CROSSROADS MIXED USE FILING NO. 2

GRADING & EROSION CONTROL PLANS

NOVEMBER 2022

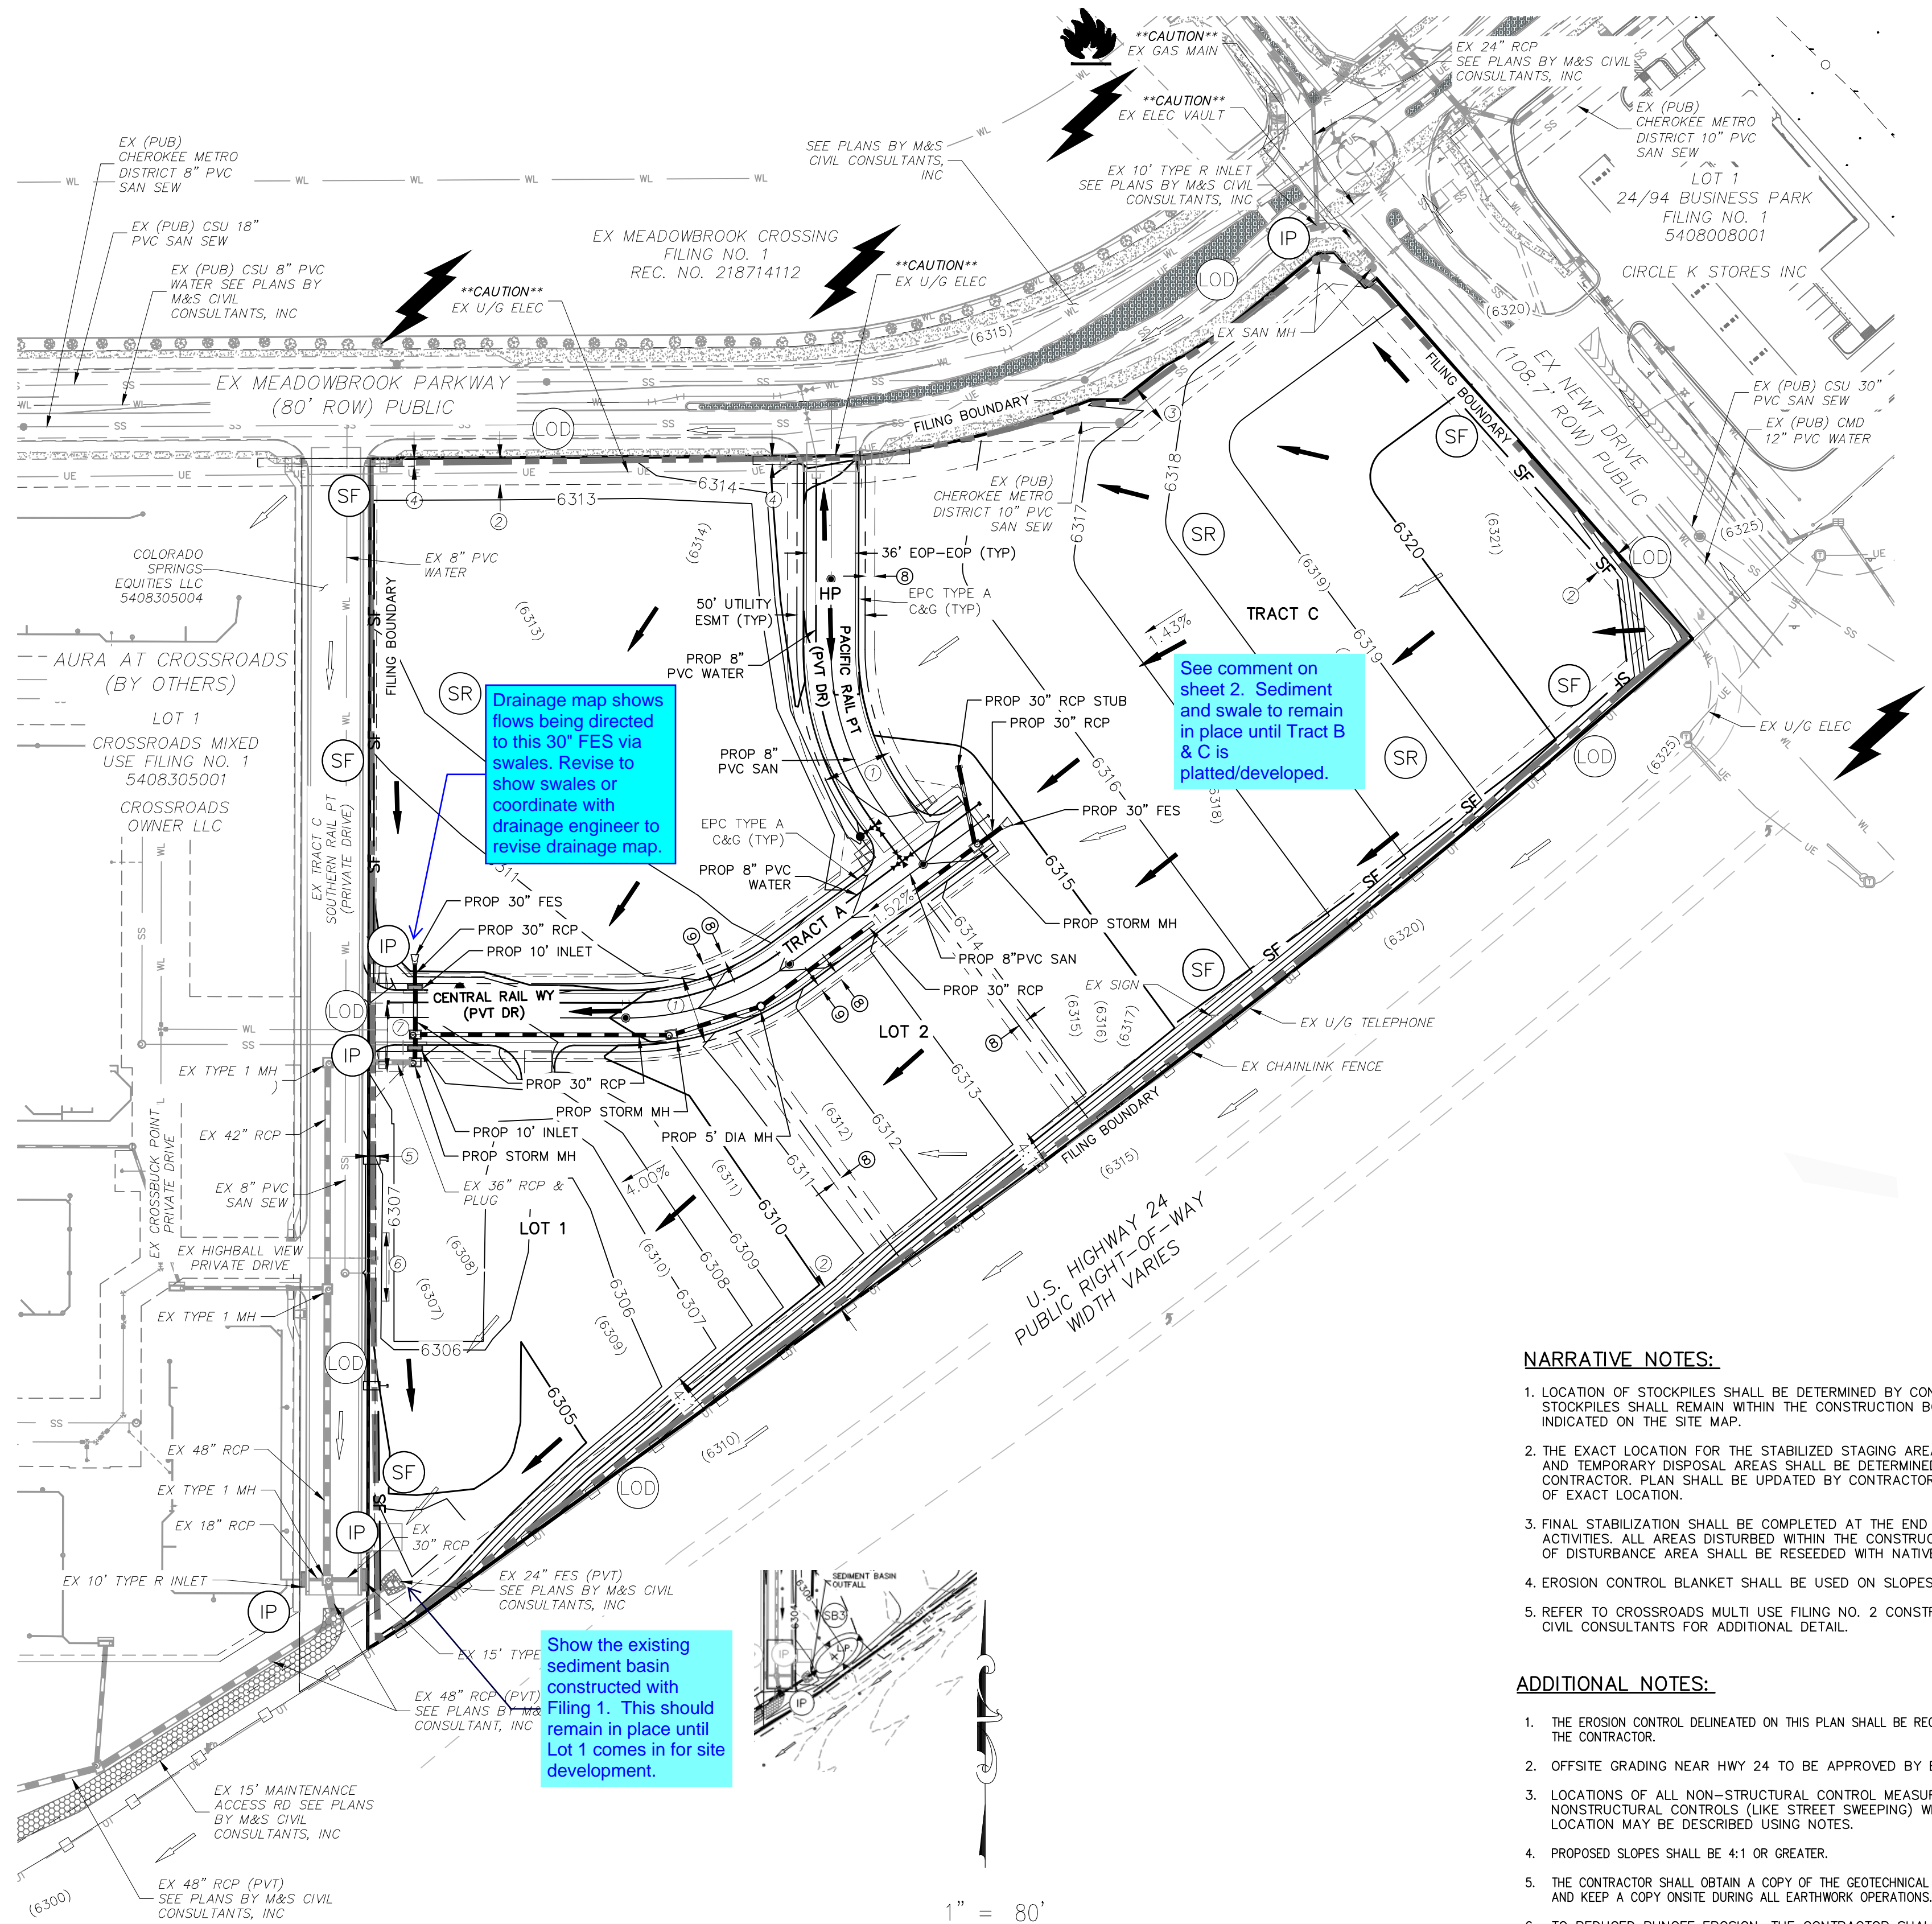
For the following temp BMPs, add them to the Legend above and the plans:
- Seeding (per Note 6 below)
- Mulching (per Note 6 below)
- Sediment Basin
- Stabilized Staging Area (add to Legend only. I see the note below about the location is TBD)
Don't need to show seeding or mulching if doing surface roughening in lieu of those. But there are details for seeding and mulching on sheet GR06, that's why I thought they were inadvertently not included on the plans and Legend.

Drainage map shows flows being directed to this 30" FES via swales. Revise to show swales or coordinate with drainage engineer to revise drainage map.

See comment on sheet 2. Sediment and swale to remain in place until Tract B & C is platted/developed.

Show the existing sediment basin constructed with Filing 1. This should remain in place until Lot 1 comes in for site development.
